INFRASTRUCTURE GROUP, INC.

May 31, 2021

Subject: 1309 - 1331 South Pacific Avenue Residential Project
Case Number: CPC-2019-4908-DB-SPR

Special Speed Study Summary: 14TH STREET

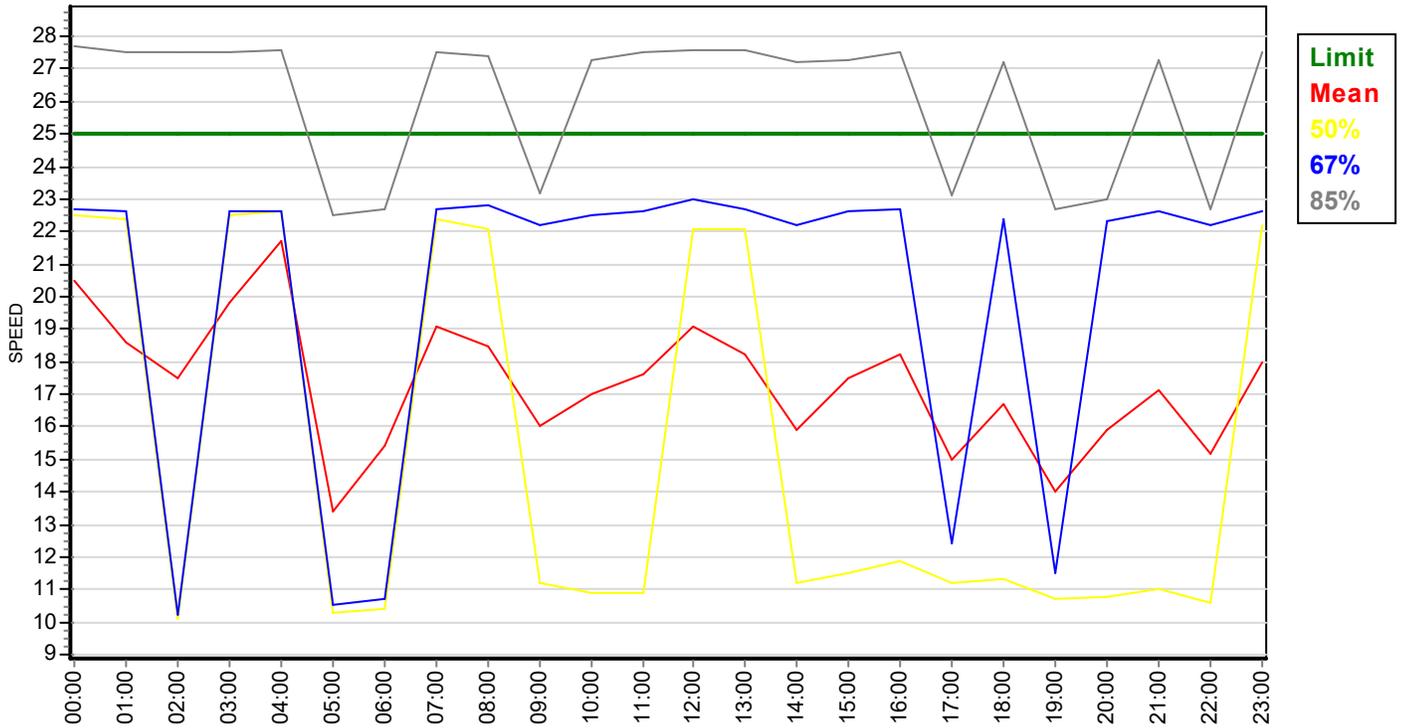
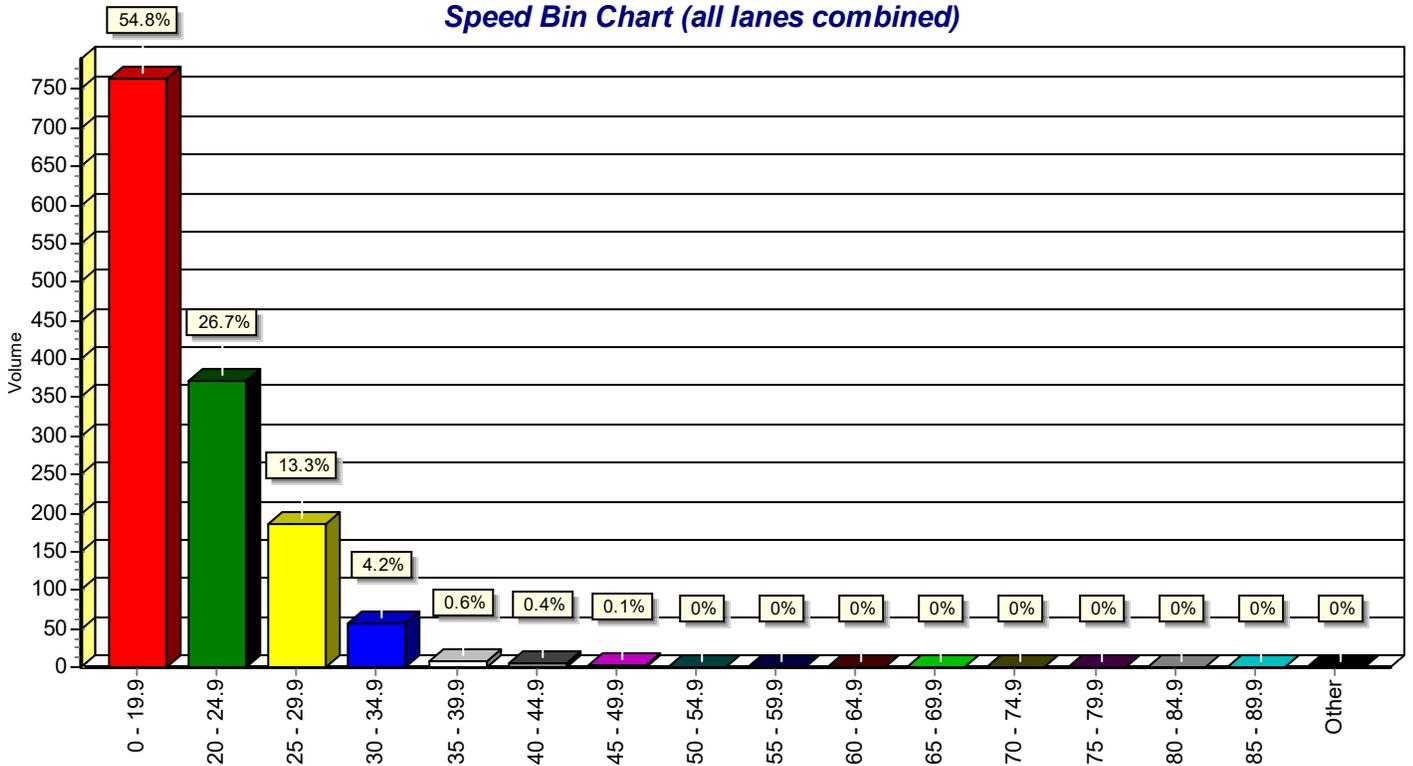
Recent traffic counts (10/2020) are available for the segment of 14th Street on which the project access is located through NavigateLA. Those counts show that 14th Street East of Grand had an ADT of 735. Even without correcting for the Traffic Study’s inappropriately discounting of net trips by counting traffic from

long-closed uses on the site, the proposed project would result in a significant Neighborhood Intrusion Impact. It is therefore ineligible for a Class 32 Exemption.
